03-15 LATEST REVISION DATE <i>Norman E. Mc Donald</i> APPROVED BY BRIDGE ENGINEER		
	STANDARD DESIGN - 40' ROADWAY, 3 SPAN BRIDGES ROLLED STEEL BEAM BRIDGES OCTOBER, 2014	
	SUBDRAIN DETAILS	RS40-170-14

OUTLET DETAILS

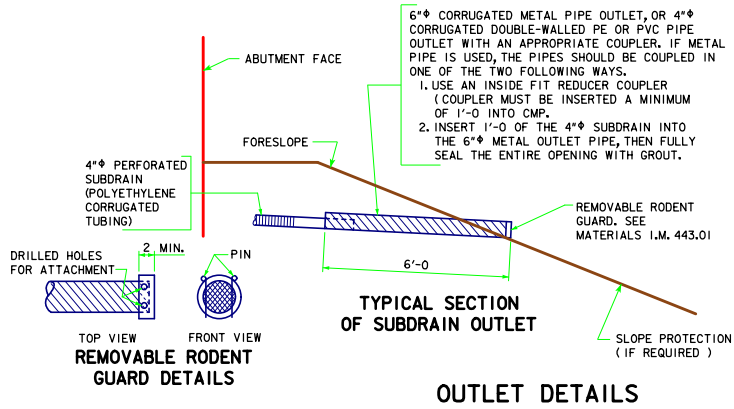
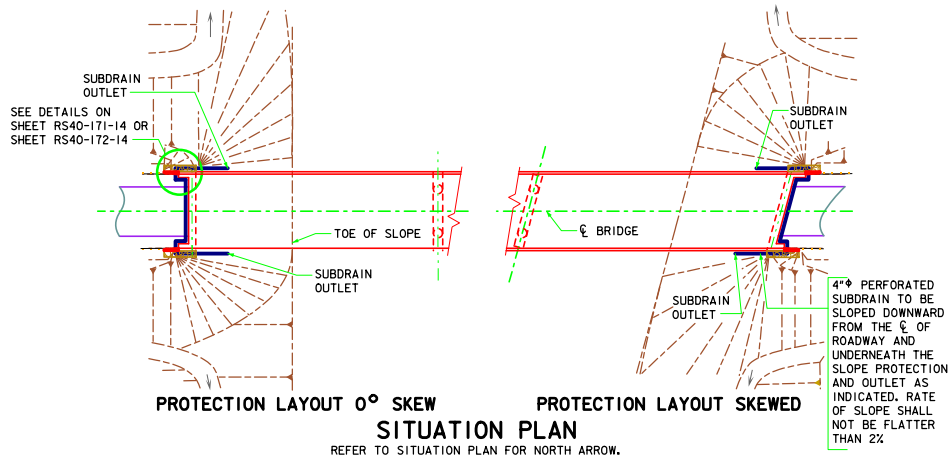
REVISED 03-15 CORRECTED THE CALLOUT "SHEET RS40-171-14 OR SHEET RS40-172-14" IT WAS IN ERROR CALLING OUT "SHEET H40-90-06 OR SHEET H40-91-06".
